NUMBER	REV	DATE	TITLE
DCN - #0188	0	05/06/94	DCN TITLE: **ADD PAD MOUNTED GEAR TO PRIMARY 13.8 KV FEEDER FOR OAB/TOB BLDG.** "APPROVED FOR CONSTRUCTION"

US DEPARTMENT OF ENERGY
HANFORD WASTE VITRIFICATION PLANT

DESIGN CHANGE NOTICE

DCN - 0188	REV 0	PAGE 1 OF 13
DCN TITLE ADD PAD MOUNTED GEAR TO PRIMARY 13.8 kV FEEDER FOR OAB/TOB BLDG		DATE INITIATED 05/05/94
		PACKAGE NO. A170

OAB/TOB SERVICE ONE LINE DIAGRAM

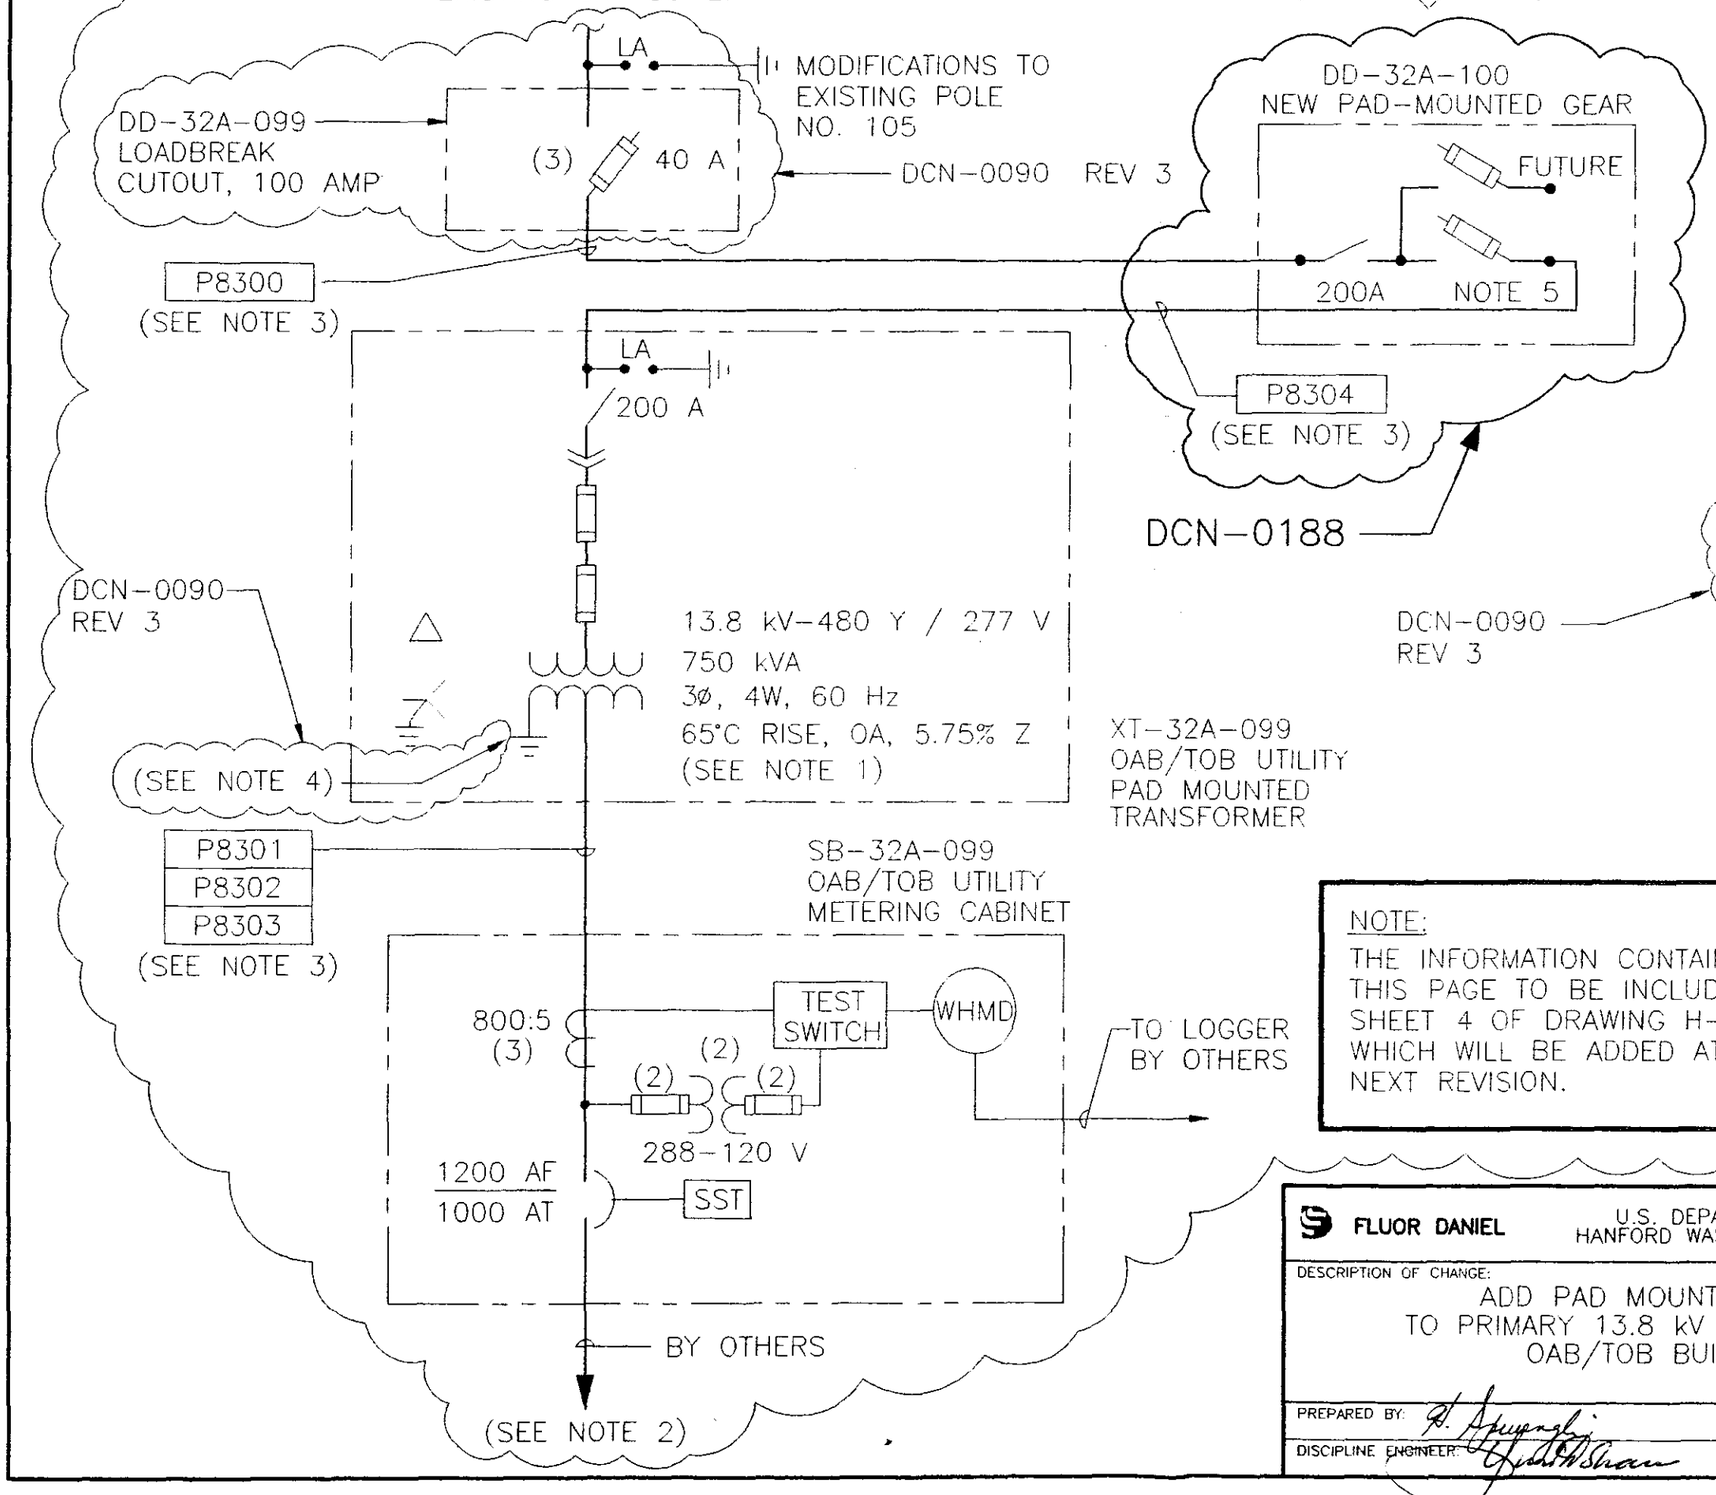
NOTE:
THE INFORMATION CONTAINED ON THIS PAGE TO BE INCLUDED ON SHEET 4 OF DRAWING H-2-122134 WHICH WILL BE ADDED AT THE NEXT REVISION.

DETAIL 23

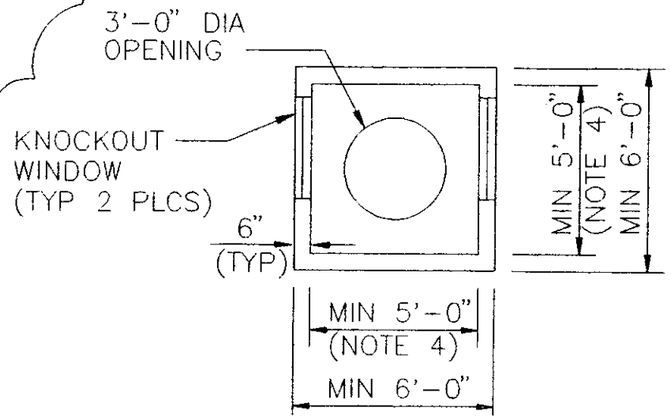
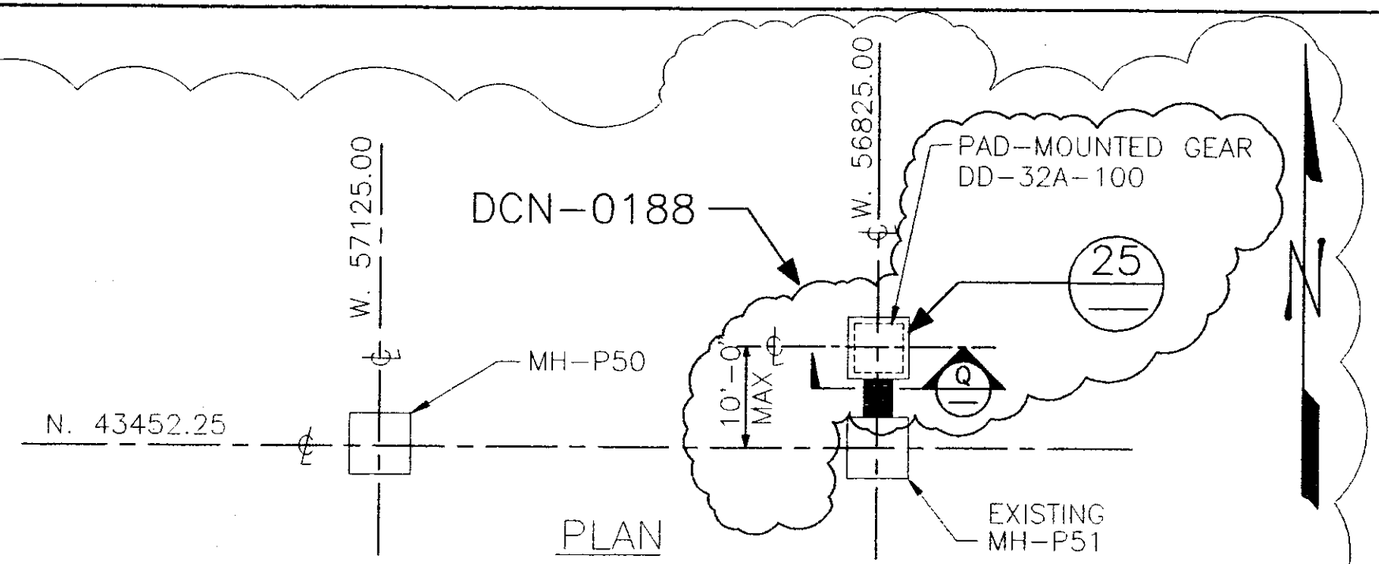
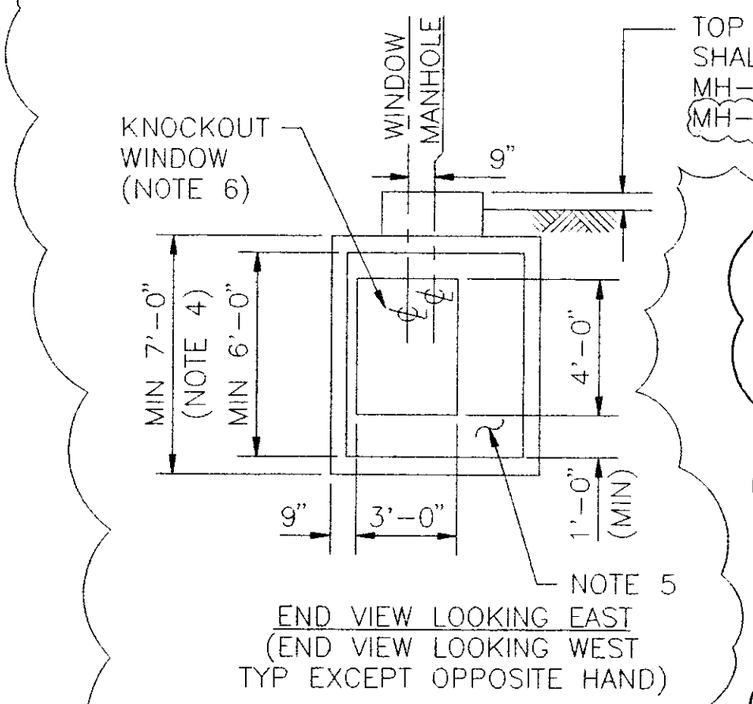
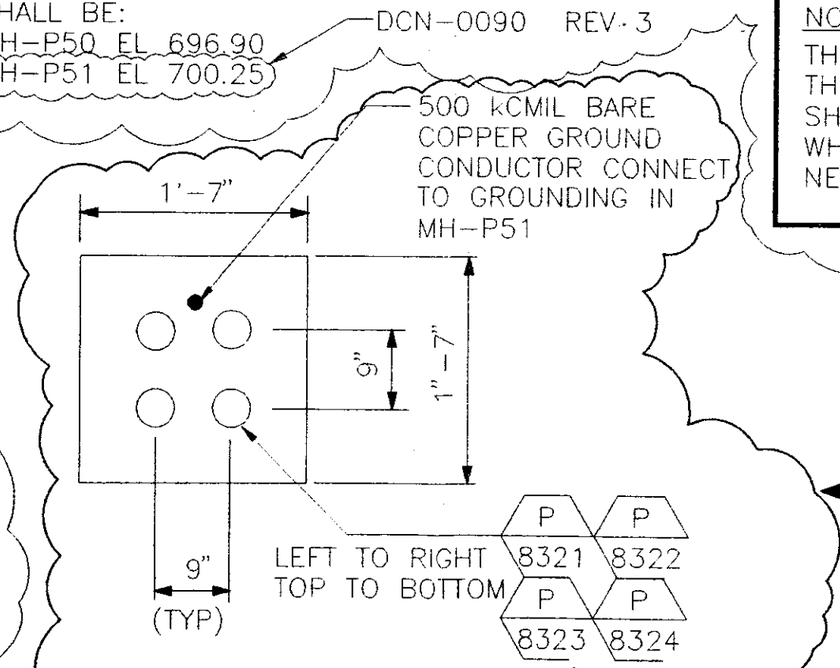
NOTE:
THE INFORMATION CONTAINED ON THIS PAGE TO BE INCLUDED ON SHEET 4 OF DRAWING H-2-122134 WHICH WILL BE ADDED AT THE NEXT REVISION.

DETAIL 25

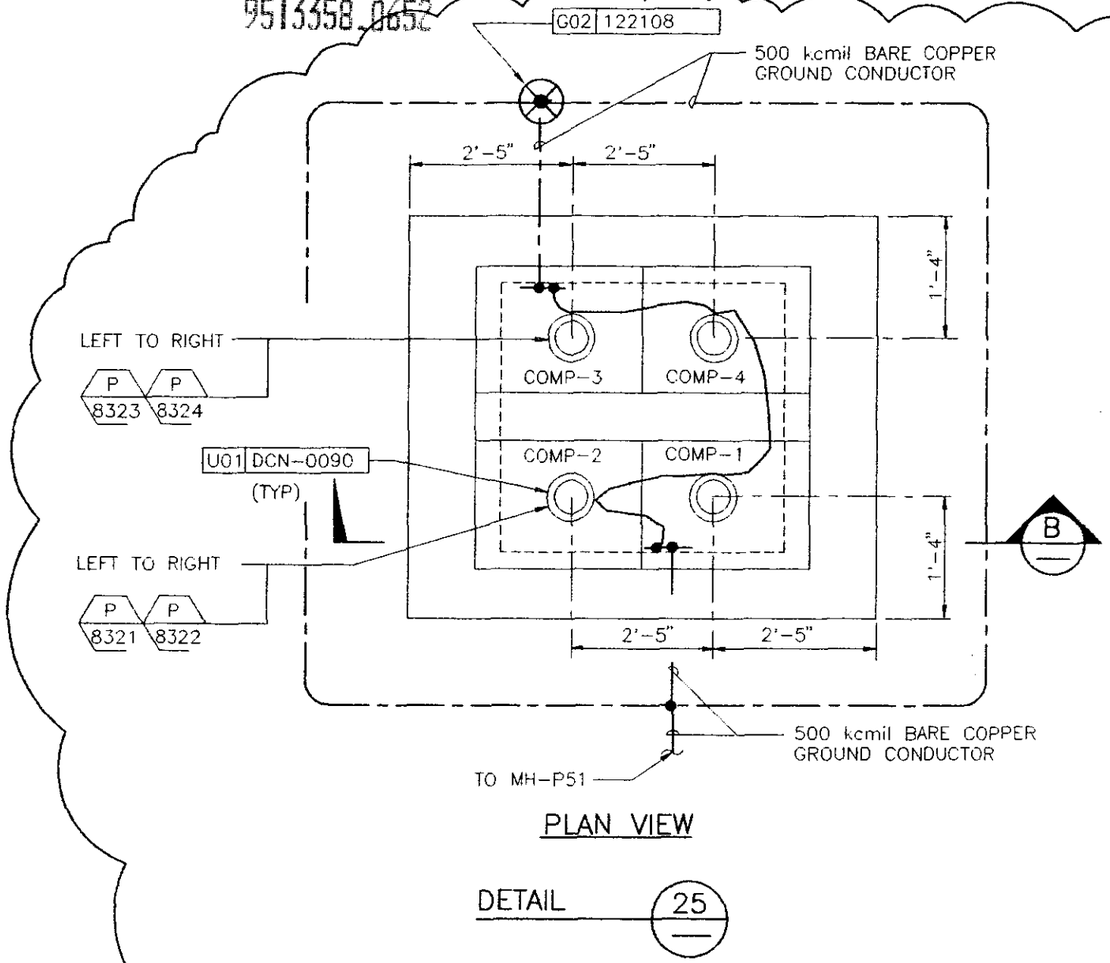
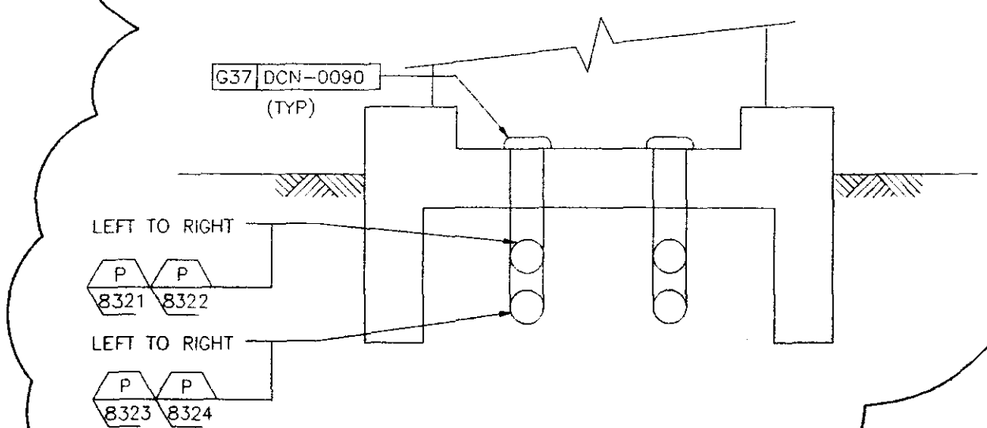
DOCUMENT NUMBER	SHT/ PAGE	REV NO	DOCUMENT NAME	INCLD Y/N	DESCRIPTION OF CHANGE
SPECIFICATION B-595-C-A170 -16111 ATTACHMENT A	1,2	0	CONDUIT SCHEDULE	Y	ADDED CONDUITS TO & FROM MH-P51 TO PAD MOUNTED GEAR
ATTACHMENT B	1	0	CABLE SCHEDULE	Y	ADDED CABLES TO PAD MOUNTED GEAR
H-2-122126	1	3	ELECTRICAL CONSTRUCTION UTILITIES OVERALL DISTRIBUTION PLAN	Y	ADDED PAD MOUNTED GEAR
H-2-122134	1	3	ELECTRICAL CONSTRUCTION UTILITIES DETAILS	Y	ADDED CONDUIT ENTRANCE TO MH-P51. REVISED ONE LINE. ADDED INSTALLATION DIAGRAM
H-2-122134	3	3	ELECTRICAL CONSTRUCTION UTILITIES DETAILS	Y	ADDED PAD WITH STUB-UPS FOR PAD MOUNTED GEAR

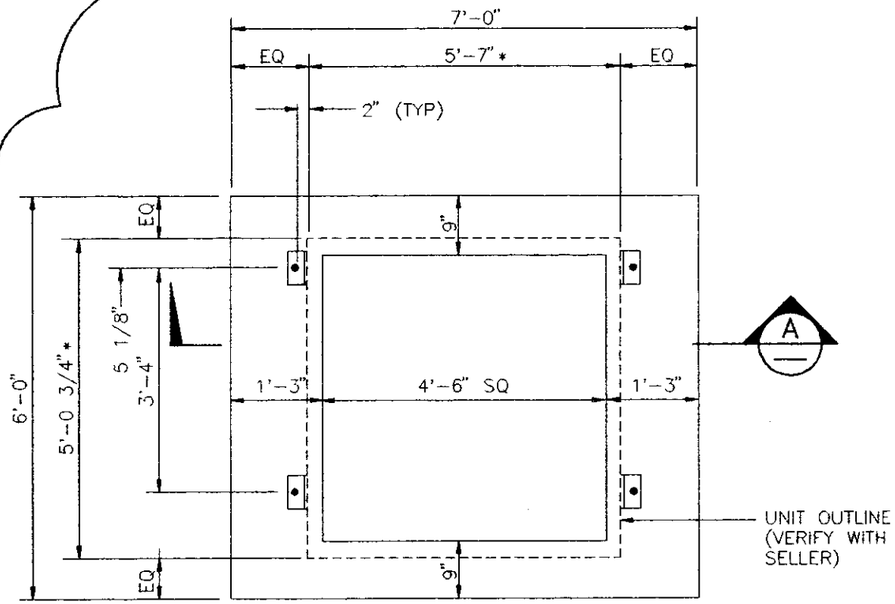
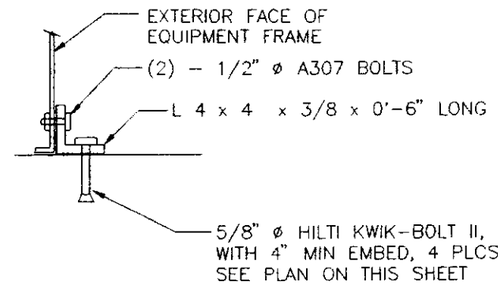
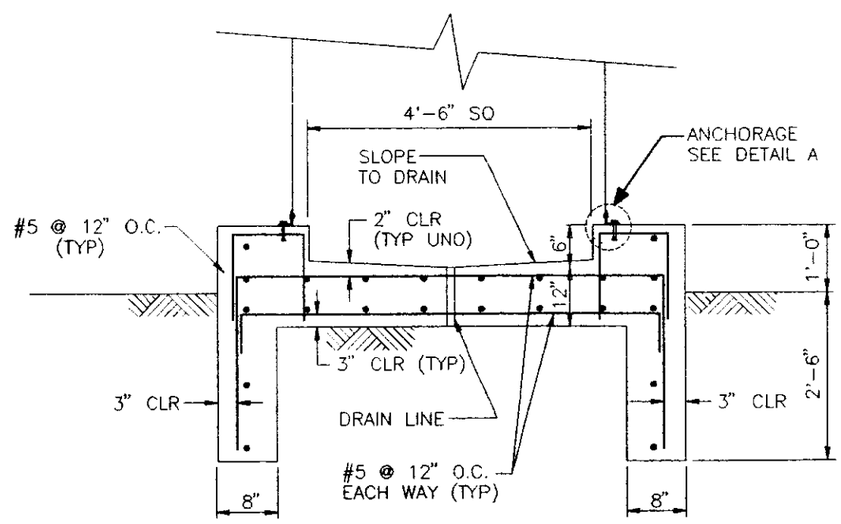
DOCUMENT NUMBER	SHT/ PAGE	REV NO	DOCUMENT NAME	INCLD Y/N	DESCRIPTION OF CHANGE
H-2-118063	1	2	DISCONNECT SWITCH PAD FOUNDATION	Y	ADDED PAD FOUNDATION FOR PAD MOUNTED GEAR NORTH OF MH-P51
